ADDENDUM #1

Issue Date: 3/17/2025
Project Name: American Family Field – Restroom Alteration
Project Address: 1 Brewers Way
Milwaukee, WI 53214

Zimmerman Project Number: 250012.01

AMERICAN FAMILY FIELD - Restroom Alteration - Corporate Office Lobby (Field Level)

1 FIELD LEVEL AREA B REFLECTED CEILING PLAN - NEW

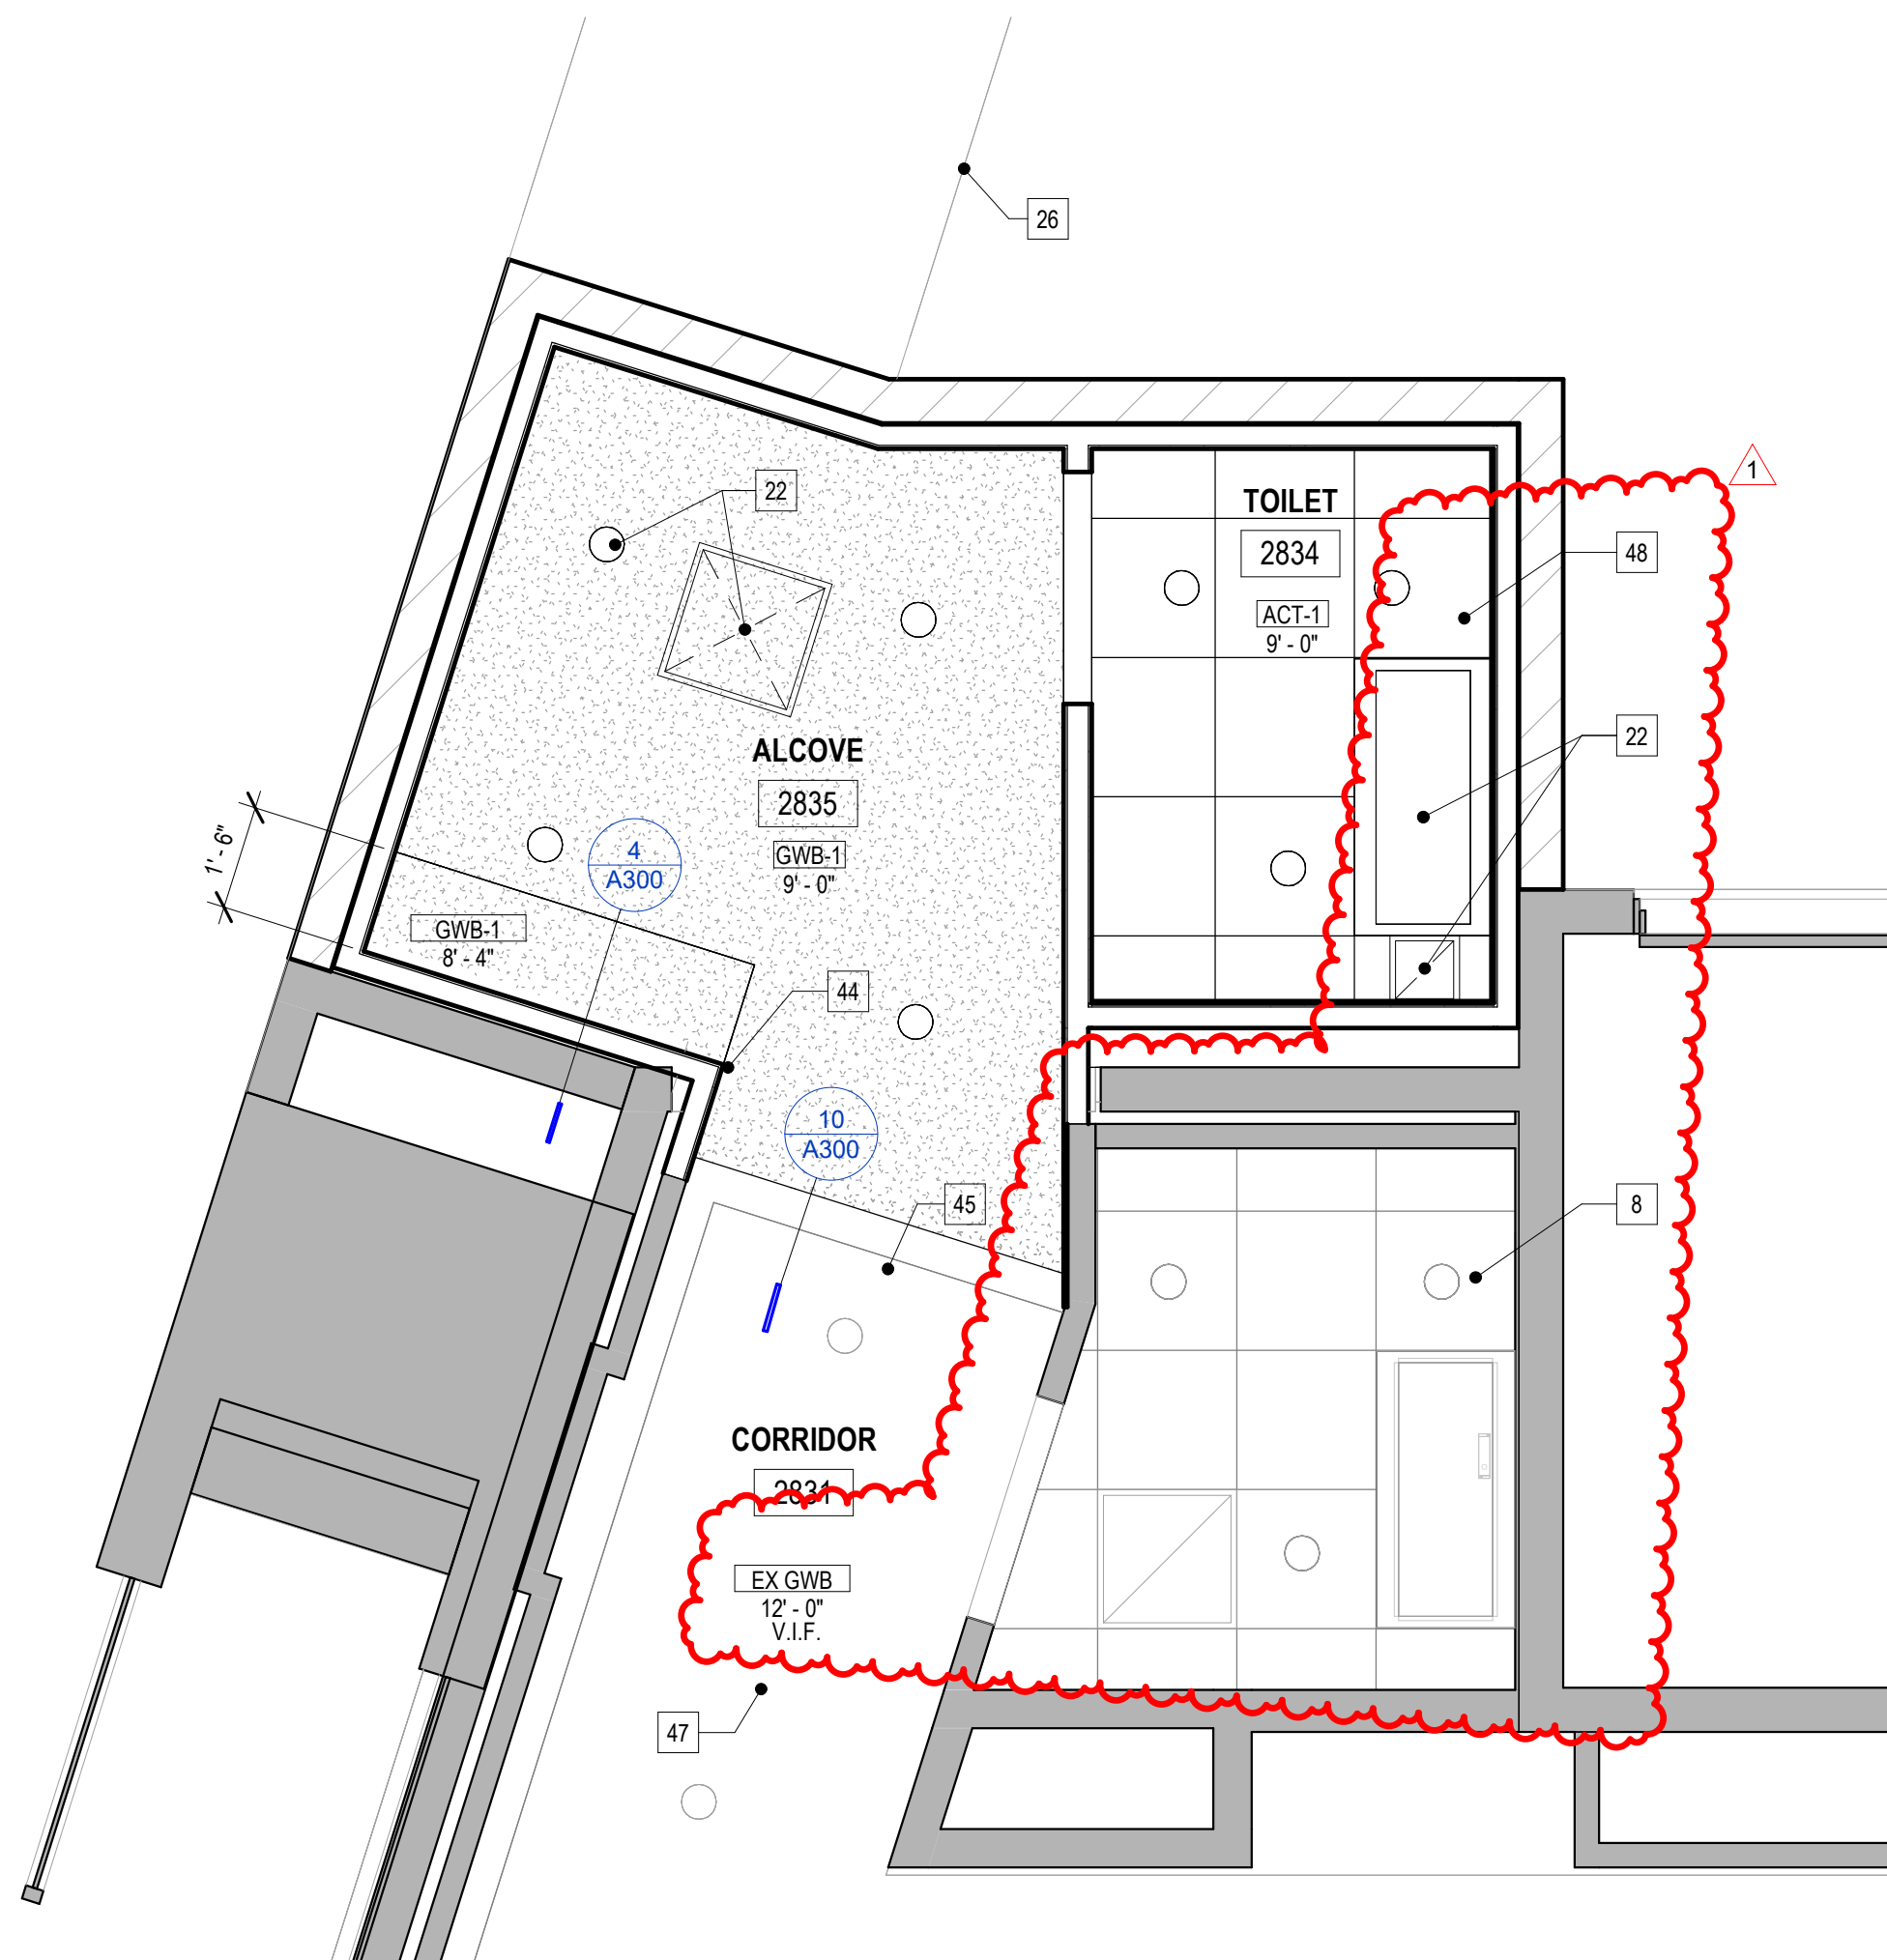
Q: The plan listed ACT-1 in the Toilet room says to match existing.... What is the existing?

- REVISE: Reprinted the original sheet that did not print properly to show keynotes per sheet and keynotes on plan.

A: Match the existing adjacent toilet room ACT. Also see the included updated Sheet A300 and the keynotes and material schedule.

#	DESCRIPTION
8	EXISTING CONSTRUCTION TO REMAIN. VERIFY IN FIELD THE EXACT CONDITIONS, MATERIALS, HEIGHTS AND REQUIREMENTS.
22	REFER TO MECHANICAL AND ELECTRICAL DRAWINGS FOR LIGHTS AND GRILLE LOCATIONS AND SELECTIONS.
26	INDICATES UNDERSIDE OF ESCALATOR CLOSER TRIM. VERIFY IN FIELD EXACT CONDITIONS, LOCATIONS AND REQUIREMENTS FOR NEW CONDITIONS.
44	ALIGN EDGE OF NEW SOFFIT WITH FACE OF NEW WALL.
45	NEW CEILING EDGE TO START AT SAME DISTANCE FROM EXISTING SOFFIT AS EXISTING OPEN SIDE WALL. VERIFY IN FIELD THE EXACT LOCATION, CONDITIONS AND REQUIREMENTS. PROVIDE A NEW FINISHED GYPSUM BOARD BULKHEAD FROM CEILING EDGE UP TO FLOOR DECK ABOVE.
47	REPLACE PORTIONS OF EXISTING SOFFIT AS REQUIRED THAT HAVE BEEN REMOVED AS NEEDED TO ACCESS AND INSTALL NEW DUCTWORK. VERIFY IN FIELD THE EXTENTS, AREAS AND REQUIREMENTS NEEDED. ALSO REFER TO MEP DRAWINGS FOR ADDITIONAL INFORMATION.
48	MATCH THE EXISTING ACT AND GRID SYSTEM IN THE ADJACENT TOILET ROOM.

1 FIELD LEVEL AREA B FLOOR PLAN - FINISHES

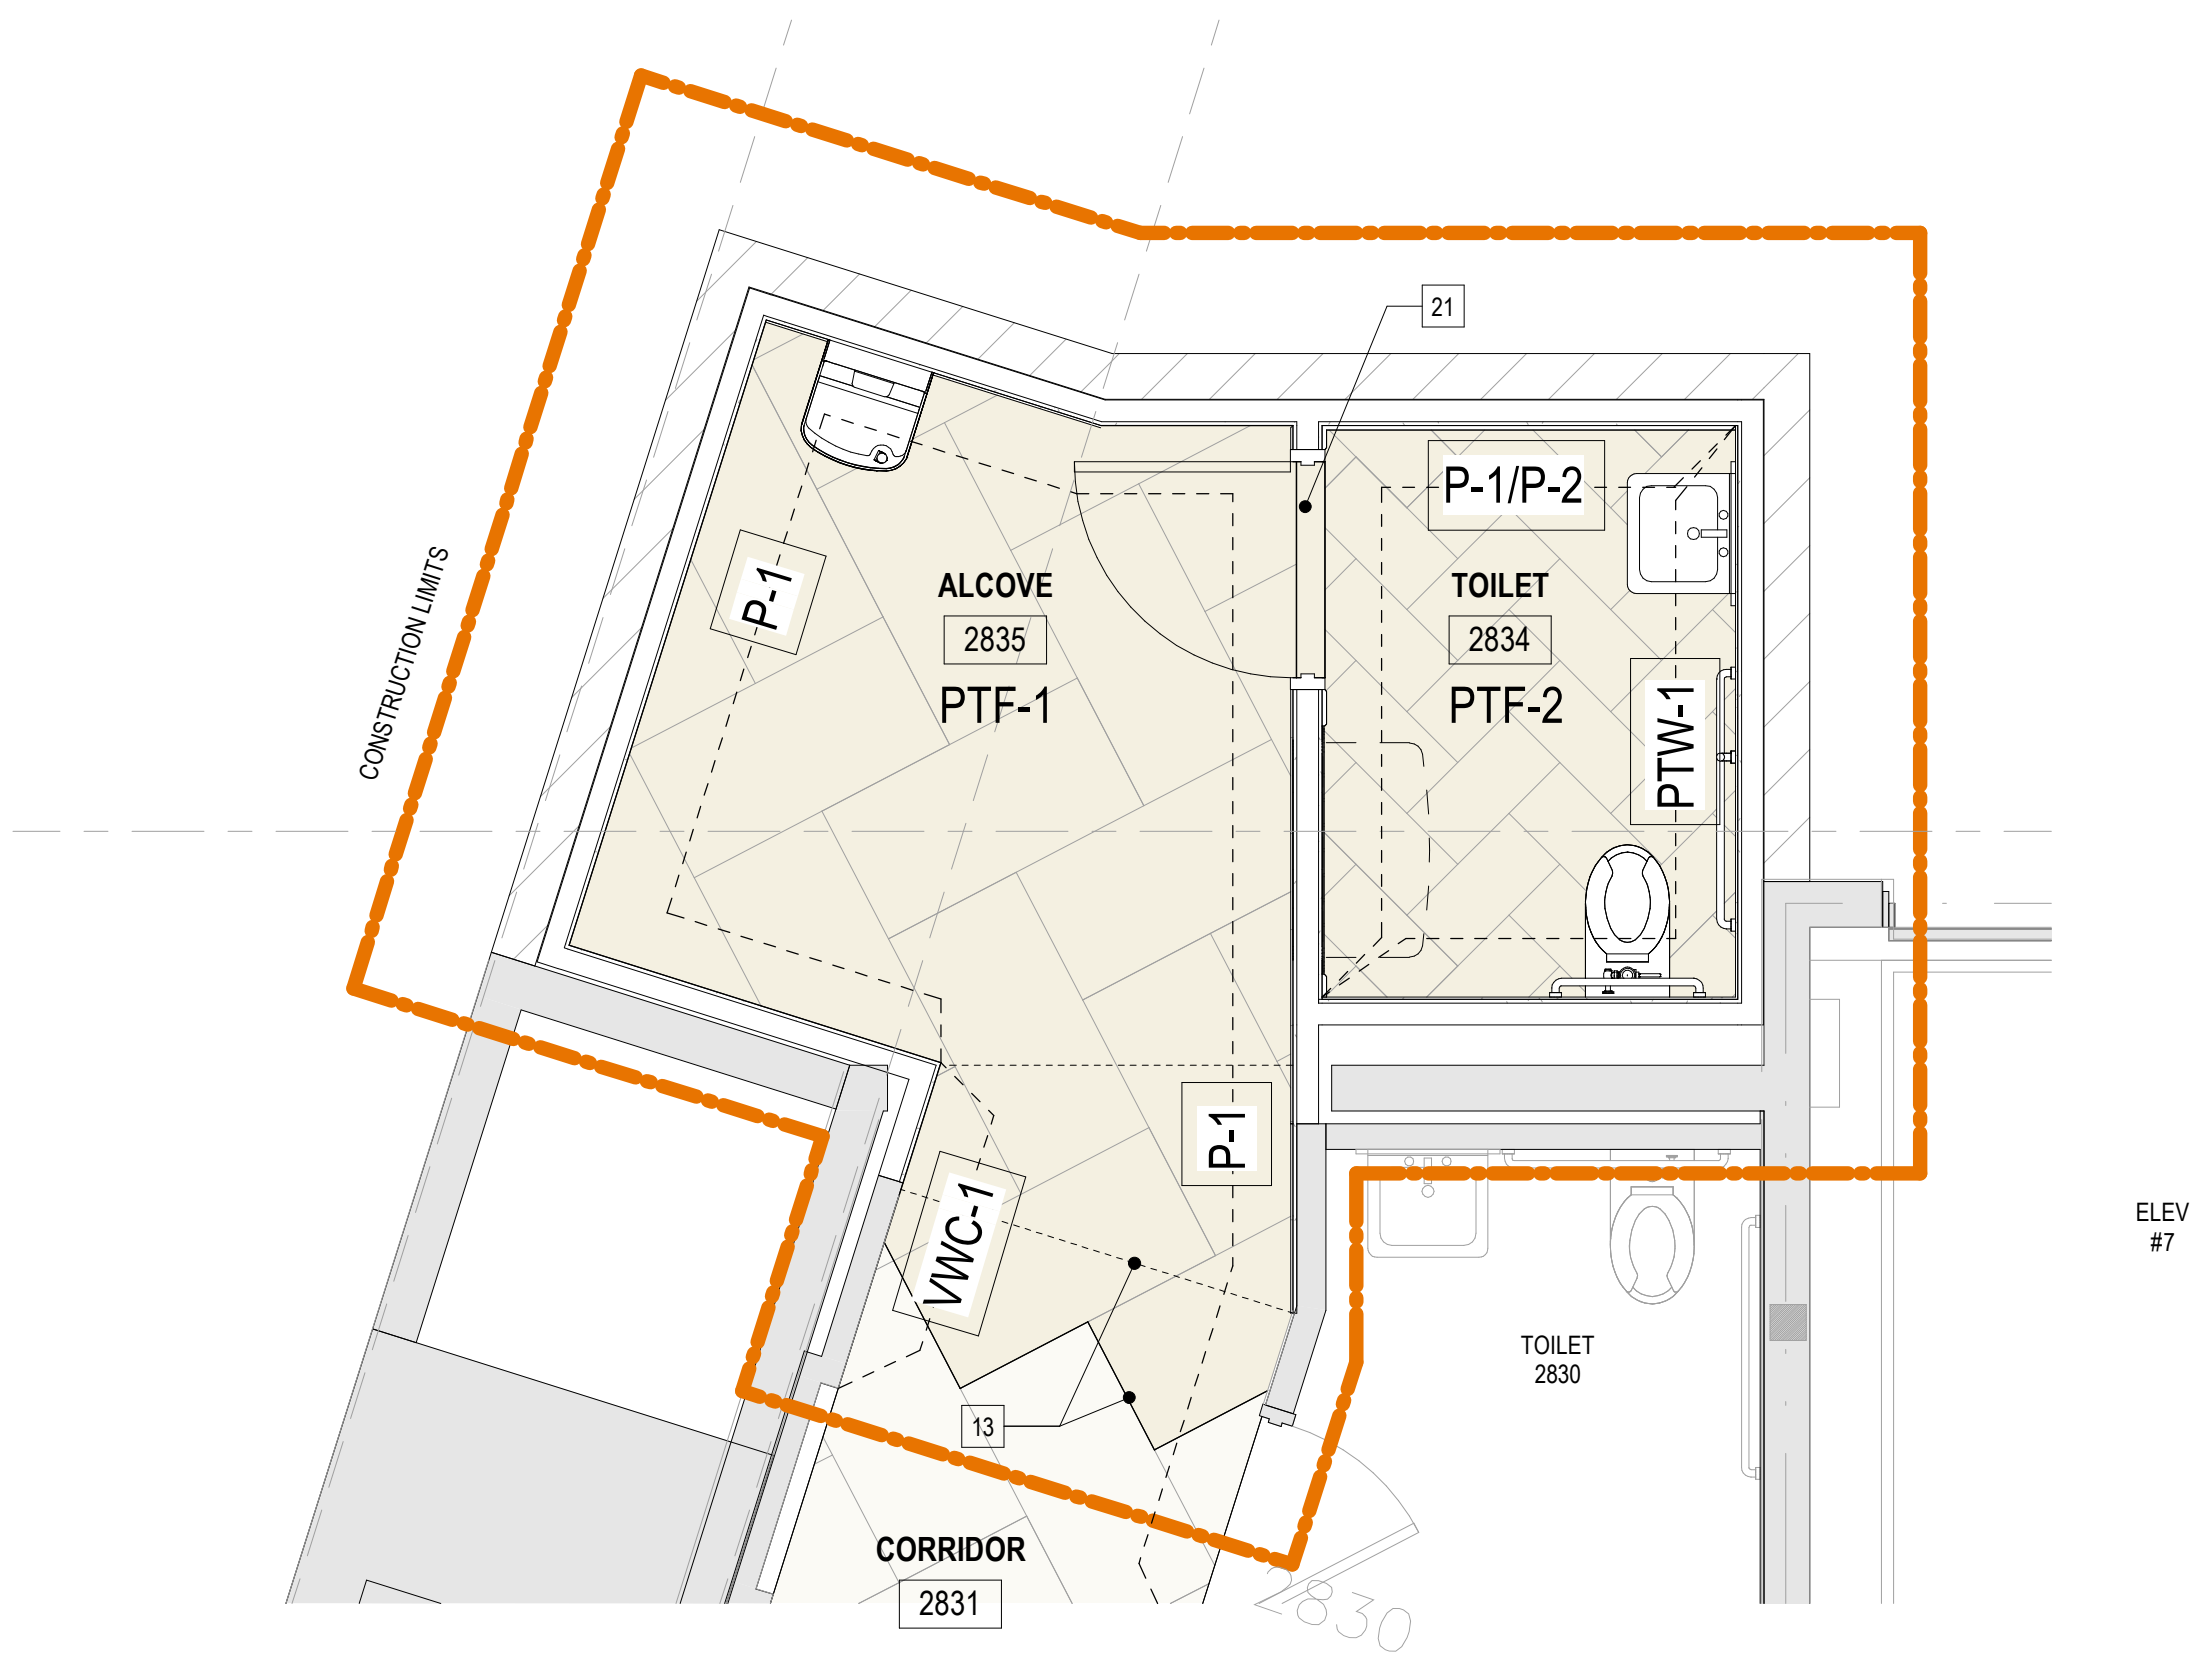
- Modify the material schedule to include the anticipated ACT-1. Contractor to field verify the match for approval.

MATERIALS AND COLORS SCHEDULE						
CODE	MATERIAL	MANUFACTURER	DESCRIPTION	NUMBER/COLOR	SIZE	REMARKS
ACT-1	Acoustical Ceiling Tile	Armstrong	Acoustical Ceiling Tile	Optima. White Regular with 15/16" Grid.	24" x 24"	Match The Existing Adjacent Toilet Room. The Anticipated Tile is Optima Regular.
Gypsum Wall Board						
GWB-1	Gypsum Wall Board		Gypsum Board Ceiling			5/8" Gypsum Board on 3 5/8" Metal Framing 16" o.c.
Paint						
P-1	Paint	Sherwin Williams	Enamel Wall Paint; Finish: Eggshell	Progreen Color: 7011 Natural Choice		Gloss Level 4. Match Existing. Base Wall Paint
P-2	Paint	Sherwin Williams	Enamel Wall Paint; Finish: Eggshell	Progreen Color: 6244 Naval		Gloss Level 4. Match Existing. Blue Wall Paint
P-3	Paint	Sherwin Williams	Enamel Wall Paint; Finish: Eggshell	Progreen Color: Match Exist Yellow Wall Color		Gloss Level 4. Match Existing. Yellow Wall Paint
P-4	Paint	Sherwin Williams	Enamel Metal Trim Paint; Finish: Satin	Progreen Color: Match Exist Door Frame Color		Gloss Level 5. For use on HM Door Frames.
